HUGHES SERVICE INFORMATION

NOTICE NO. N-28 DATE April 1, 1967 PAGE 1 OF ________

REMOVAL - AN960-416L WASHERS, ENGINE COOLING SHROUD SIDE PANEL ASSEMBLIES

All 269A Series Helicopters.

Figure 1. Engine Cooling Shroud Side Panel Assembly

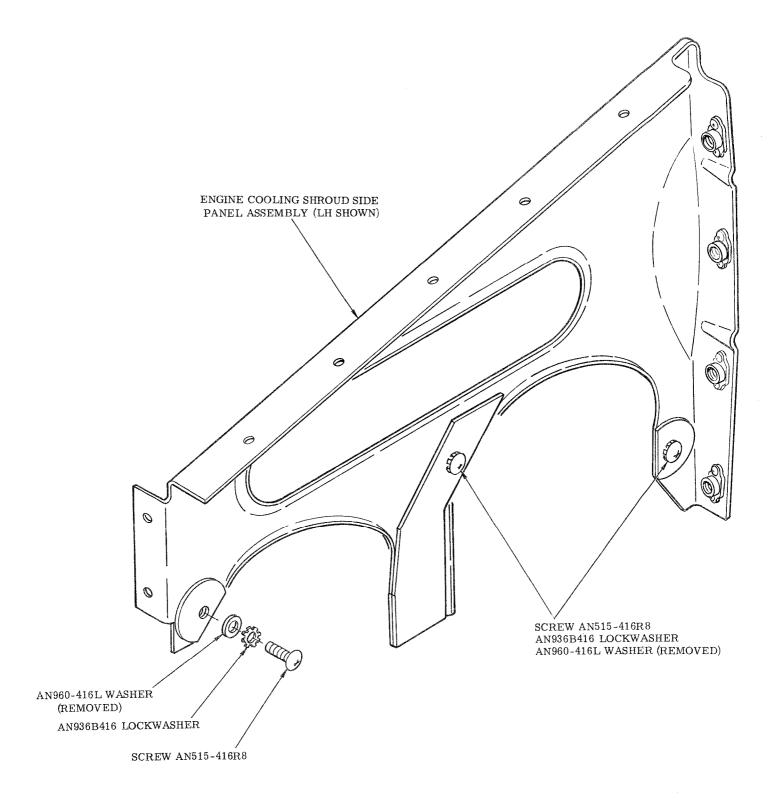
To increase security of attachment screws on engine

cooling shroud side panel assemblies.

- a. Remove six each AN515-416R8 screws, AN936B416 lockwashers, and AN960-416L (flat) washers from LH side and RH side engine cooling shroud panel assemblies. (Refer to Figure 1)
- b. Reinstall screws and lockwashers only.
